PACIFIC SCIENTIFIC COMPANY

SERVICE BULLETIN

ROTARY BUCKLE

CREW AND ATTENDANTS' AIRCRAFT SEATS

FIGURE 1

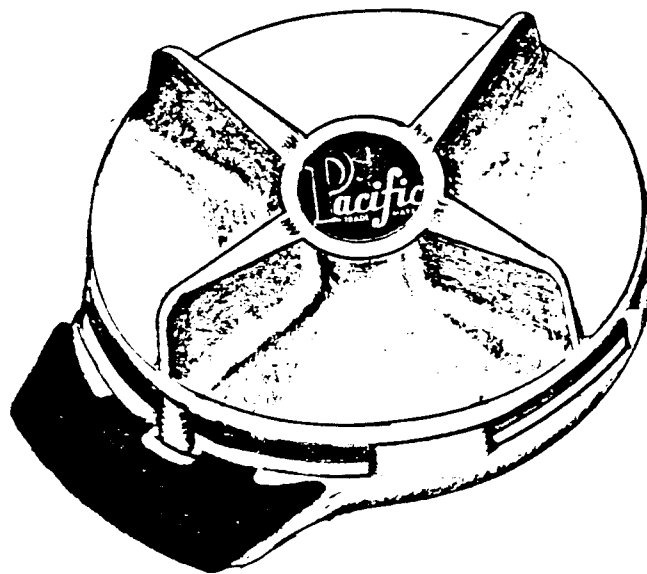
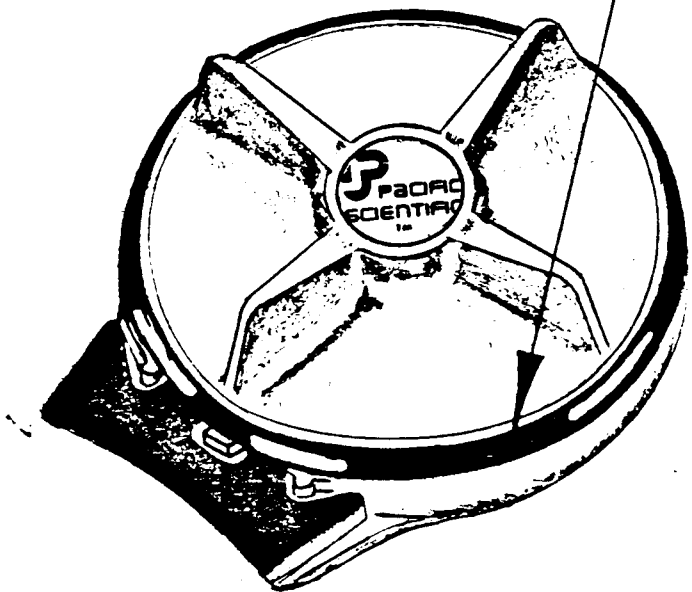
To remove earlier models from service. New models, as later identified, significantly improve load-carrying capabilities and release more easily when the system is heavily loaded (i.e., when a seat occupant is hanging upside-down with full weight on the restraint system).

Buckles manufactured since 1970 (app.) are distinguishable from earlier models in that the body plate assy. (Ref: Index No. 8, page 6 of Overhaul Manual w/IPB, #25-11-19) is finished in either gold or black color. Also, any models having two vanes rather than four indicate earlier models which should have been replaced. The outer edge of this part is visible in the completed assembly. (See Figure 1). This part (Index No. 8) is not utilized on the models to be replaced. The maintenance action consists of replacing the earlier buckles with those described in Manual #25-11-19. The buckles are physically interchangeable.

The basic part number of the replacement buckle is 1101550. Dash numbers indicate "permanent attachment", (-01 identifies right hand belt is permanently attached, -03 the left hand attachment and the -05 shows attachment to the crotch strap).

Remove strap to which buckle is attached by inserting a knife blade in the slot and forcing the catch downward until strap can be pulled free.

Snap fitting of same strap in place.
